# DEVELOPMENT REVIEW BOARD REPORT

MEETING DATE: September 21, 2006

CASE NUMBER/ PROJECT NAME	<b>49-DR-2006</b> <b>Frontier Street Shops</b>		
LOCATION	7420 E. Main Street		
REQUEST	Request approval of a site plan, landscape plan, and elevations for retail shops on East Main Street.		
OWNER	Ortega Family Holdings LLC 480-991-4224	ENGINEER	N/A
ARCHITECT/ DESIGNER	David D Ortega, AIA 480-991-4224	APPLICANT/ COORDINATOR	David D Ortega, AIA 480-991-4224
BACKGROUND	<p><b>Zoning.</b></p> <p>The subject property is currently zoned Central Business District Downtown Overlay (C-2/DO), which permits all uses in the (C-1) neighborhood commercial district, plus commercial activities designed to serve the community. This district includes uses usually associated with the central business district and shopping facilities, which are not ordinarily compatible with residential development.</p> <p><b>Context.</b></p> <p>The site is located approximately 55 feet west of the northwest corner of East Main Street and North Brown Avenue. The site is surrounded by other commercial developments.</p> <p>Adjacent Uses:</p> <ul style="list-style-type: none"><li>• North: Retail use, zoned C-2 DO</li><li>• Sou

ATTACHMENT #6

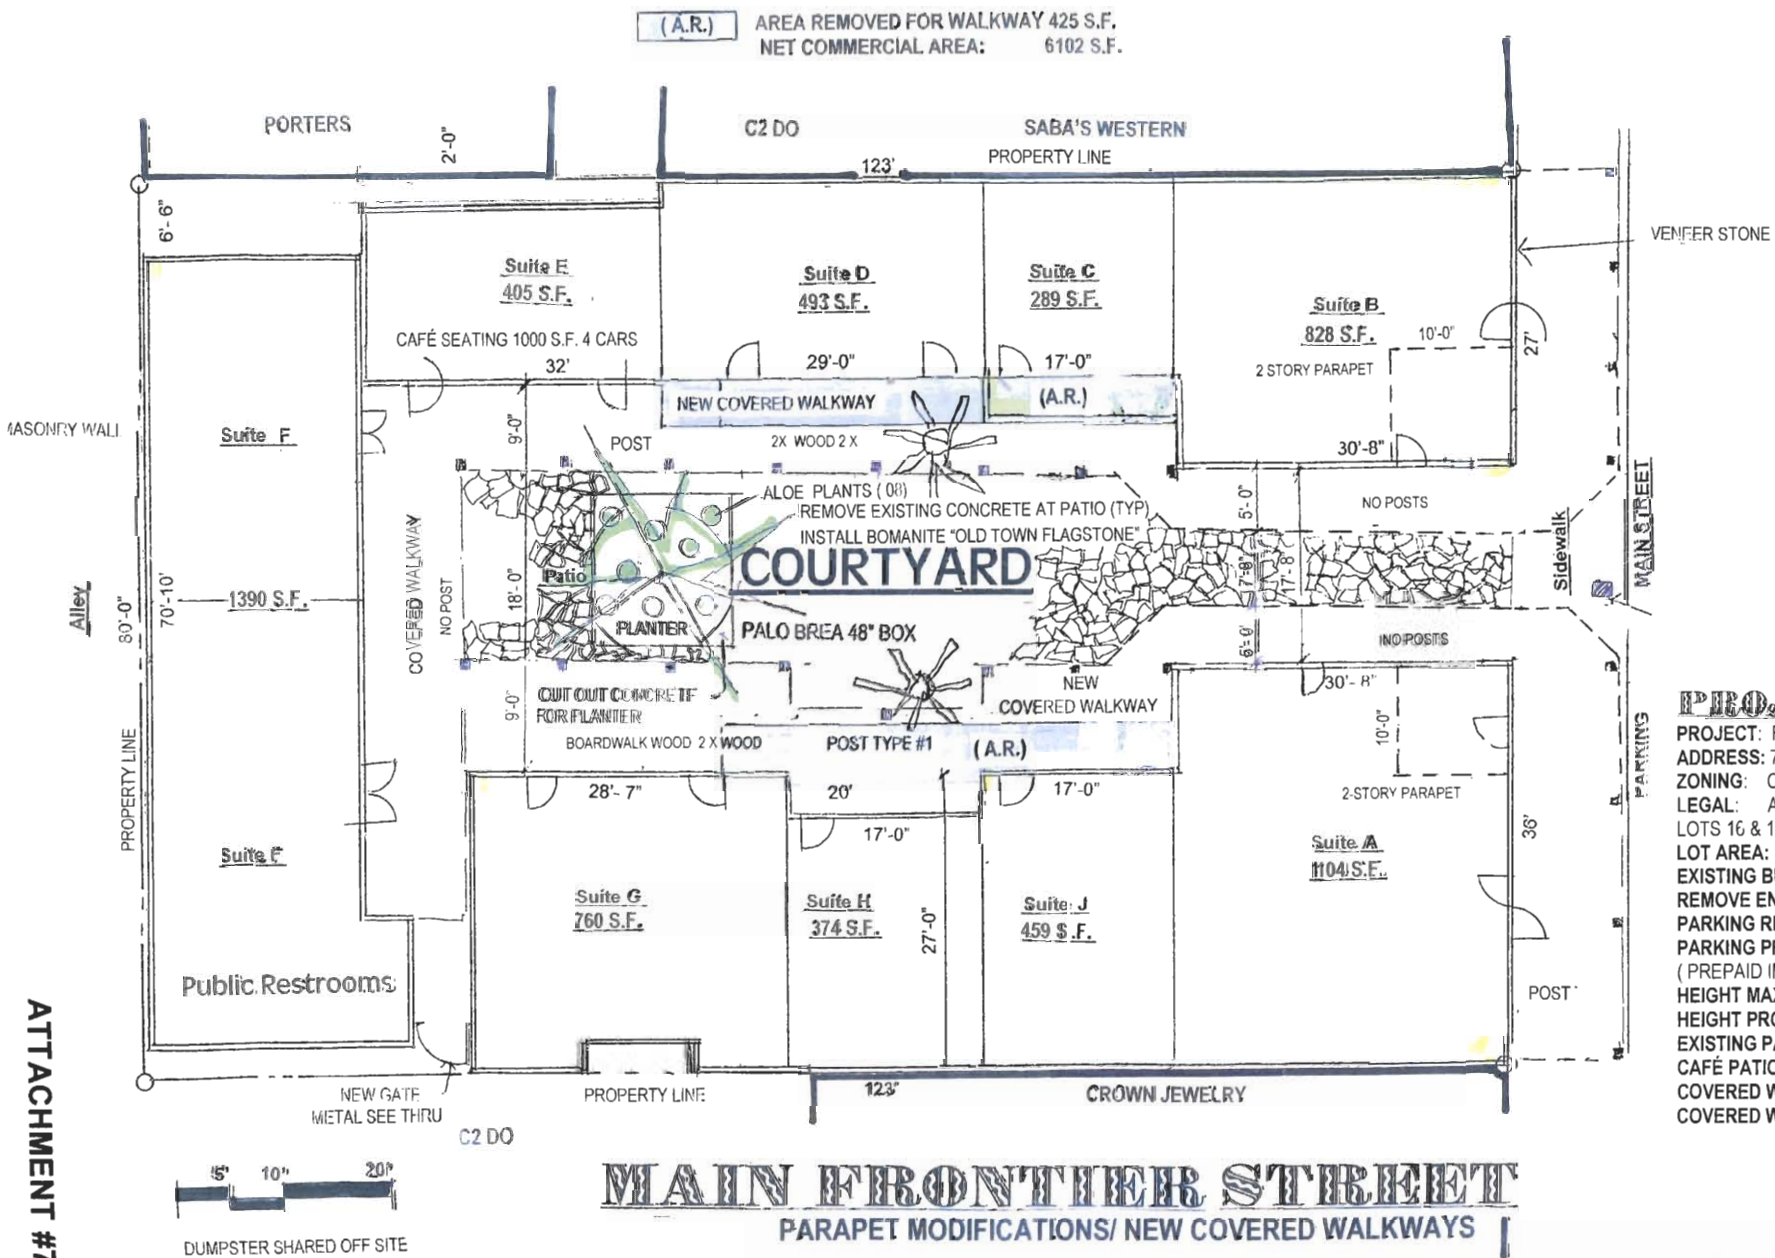
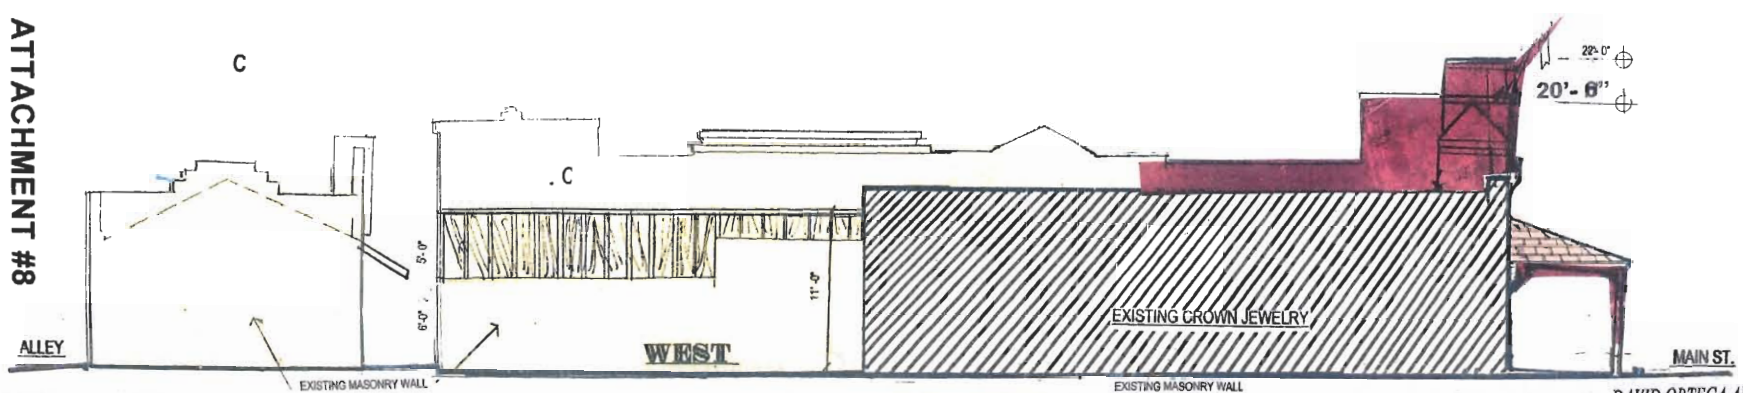
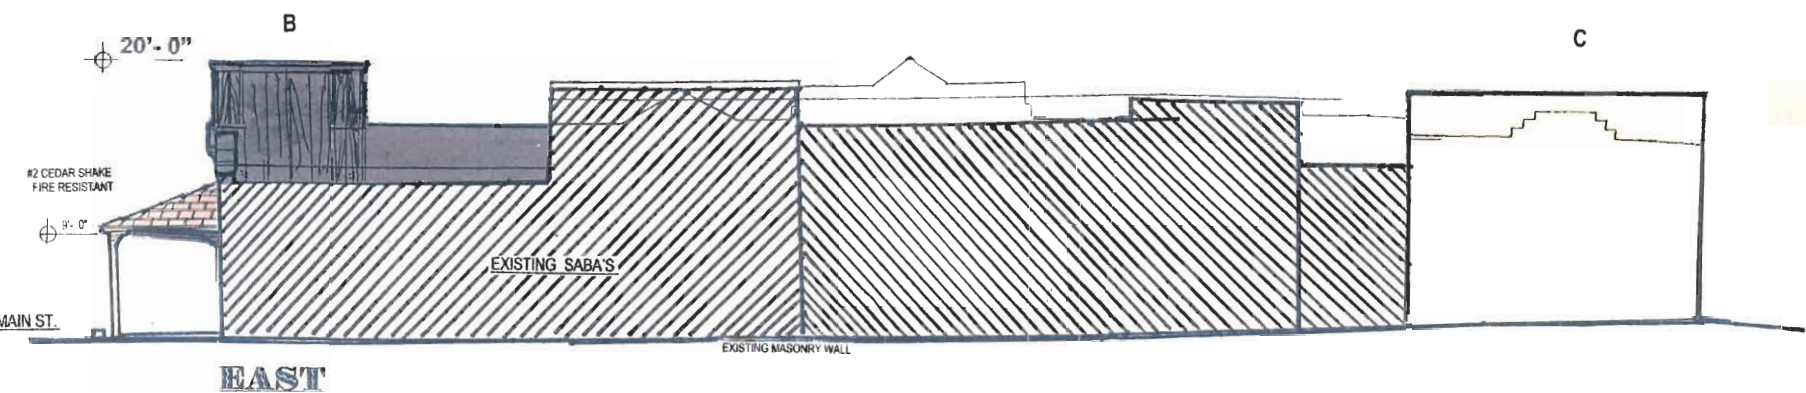
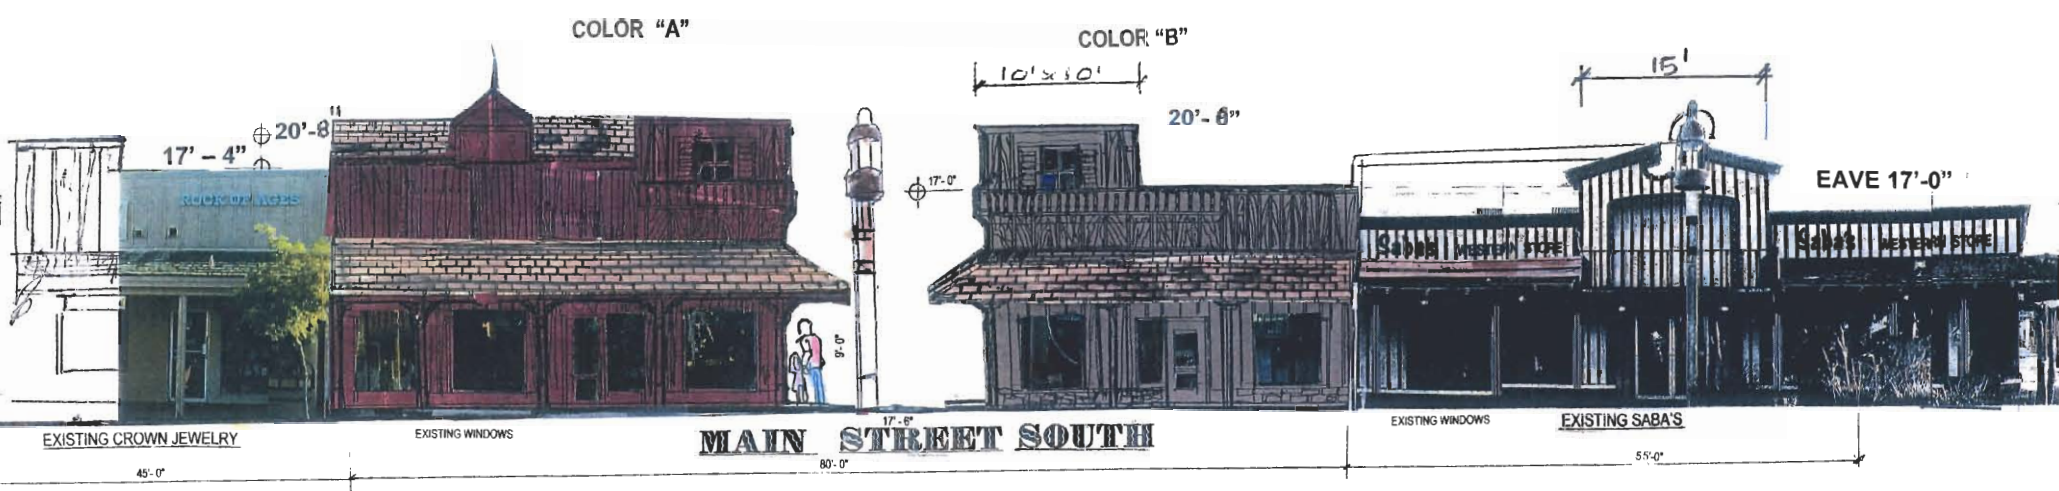
18. SITE PLAN: The developer shall submit a site plan showing the proposed improvements, alleys, streets, sidewalks, curb & gutter etc... as required per the City of Scottsdale submittal requirements  
The final plans shall show sidewalk width between posts to be a minimum 6 foot clear.

- 1) Sht 1/8 & 3/8 Site Plan indicates entry posts in line with the existing opening.
- 2) Sht 3/8 Site Plan Suspended walkway canopy joins sidewalk canopy with 45 degree corner. The inner passage walkway is desirable per Downtown Guidelines.
- 3) Sht 1/8, 2/8, 4/8 & 5/8 The west building has a shake roof rather than wood slats and the West building board and batt is all vertical.
- 4) Sht 8/8 Window and Wood Rail Details indicate rustic window and turned wood balusters similar to Sabas balcony feature.

ATTACHMENT #8

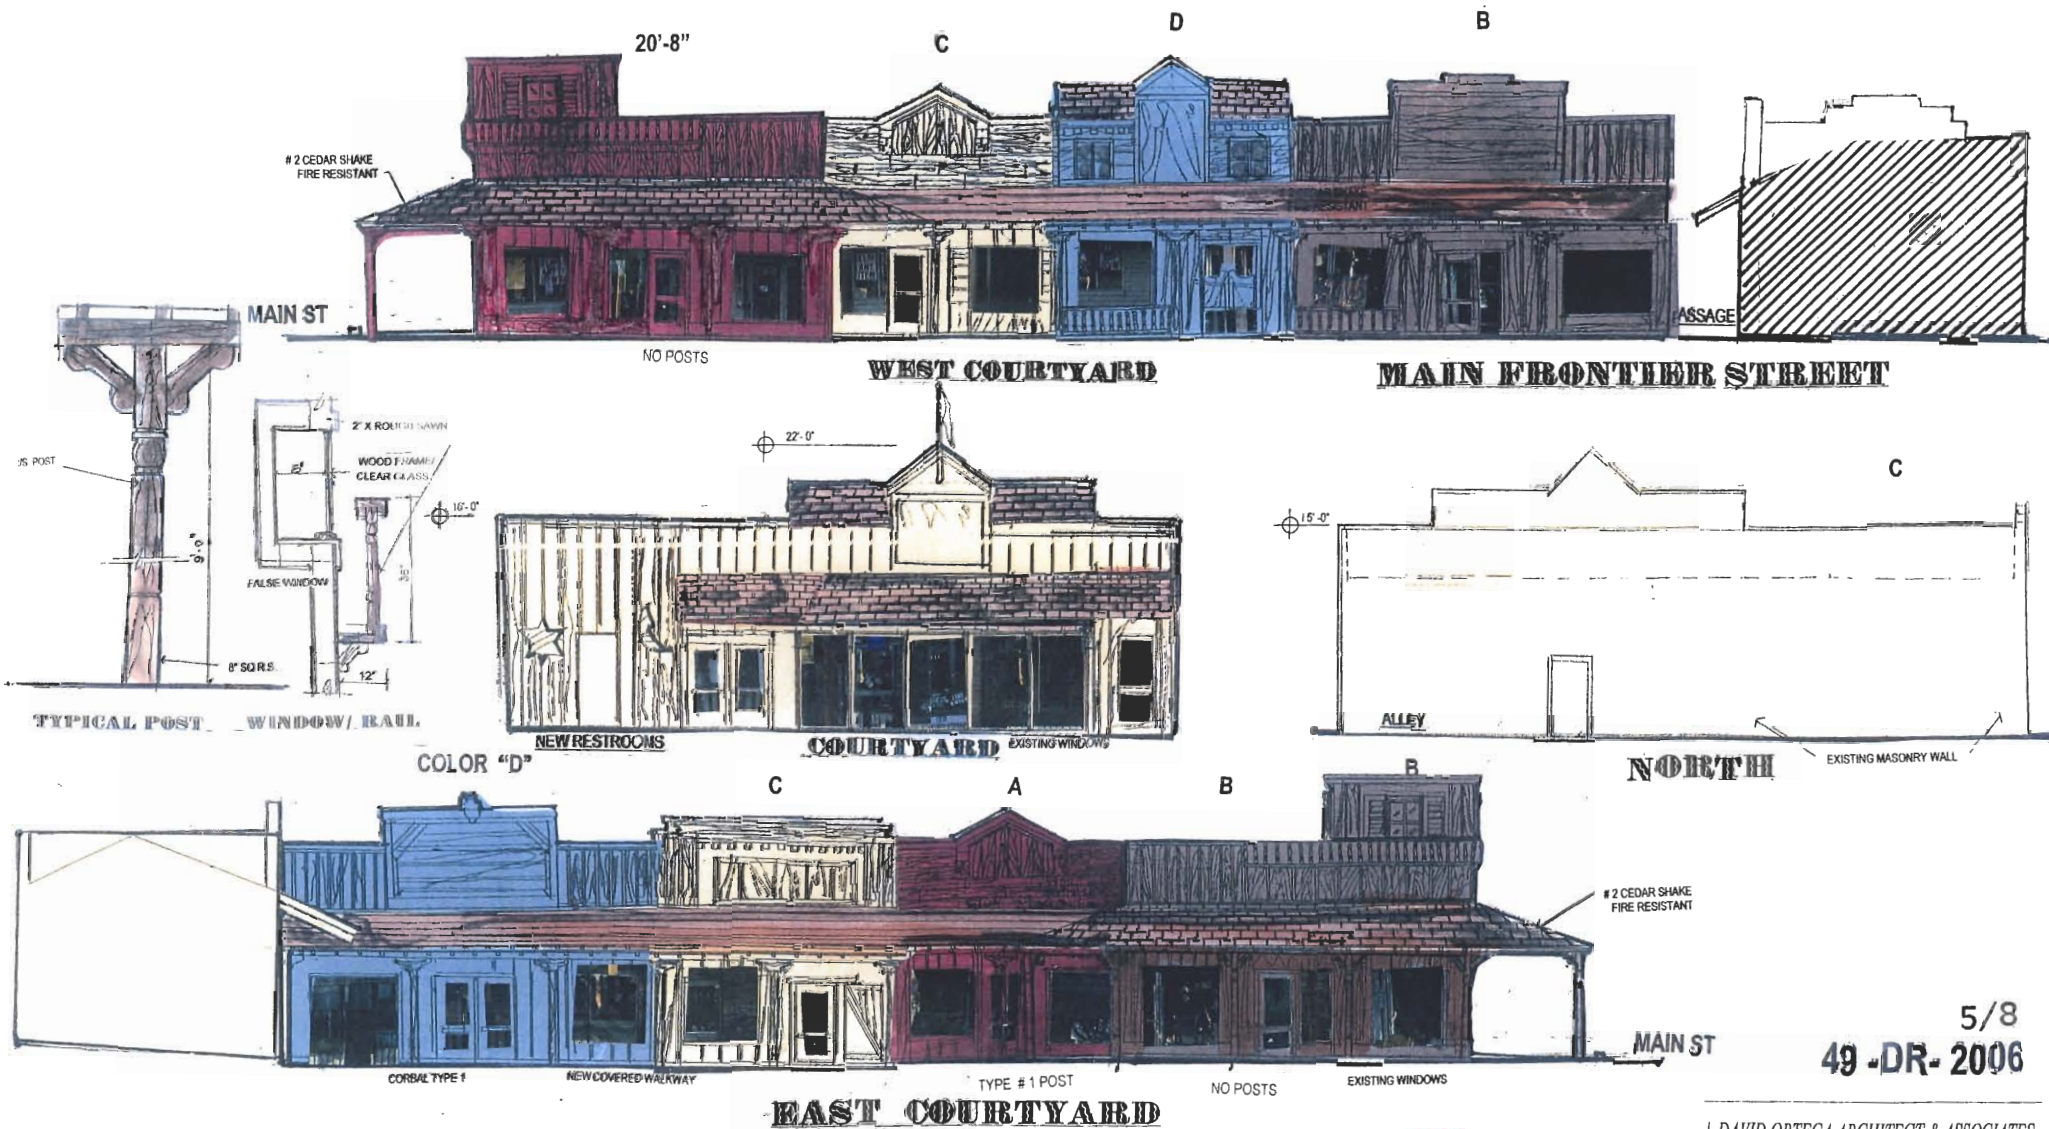
1. Provide a post at the corner of the roof where the arcade opening is, or the use of brackets to maintain the clearance.
2. Tone down the colors or blend the colors with the adjacent buildings.
3. The color contrast between the yellow and the other colors.
4. Consider the use of paned windows on the lower levels.
5. Roof material
6. Provide an entrance from suites A and B to the rear side street (alley and parking).
7. Consider turning the wood planks on the west building vertically instead of horizontally.
8. Consider how the detailing of the roof and roof corners will functionally work.
9. Revise all plans so that they are consistent.

different proportions. But the one possibility that we have been looking at up here is that maybe if you had a post right on the corner of your roof on either side, it might form more of a gateway and not leave that corner hanging out so loosely. And that one option for maintaining your clearance without the post would be to actually add some brackets; I mean, I'm not an expert on this kind of building. I don't do this kind of thing so I'm kind of guessing. And you know, you do it in more of a scenic way and a fun way here, so I appreciate that. But it just seems like it might complete the scene and still work for everything quite well to move some posts out to those corners and then support the portions of your side-roofs down the alley there that don't have posts with brackets so you get a sense of the continuity. And I wondered how you felt about that.

One thing that really does concern me is that I'm looking at the building plan, the elevation, and the perspective drawings and they don't match; they are all different. For example on the building plan here, the overhanging canopy along the street angles as you turn back down into your alleyway or your internal street. On the perspective it comes to a right angle, and nothing -- you know it seems like there are some idea's that are incubating here, but all the drawings haven't quite caught up with your thinking perhaps. So that's just my concern at this point.

- A. Provided a column on the east and west arcades that is aligned with the building corners.
- B. Turned the wood planks vertically above the arcade of the west build.
- C. Using cedar shake shingles on all of the angled roofs.
- D. Clarified the existence of an entrance and proposed gate between Building A and B.
- E. Revised the plans so that they are consistent.
- F. Provided additional detailing on the plans, and limited the number of different columns types to one.
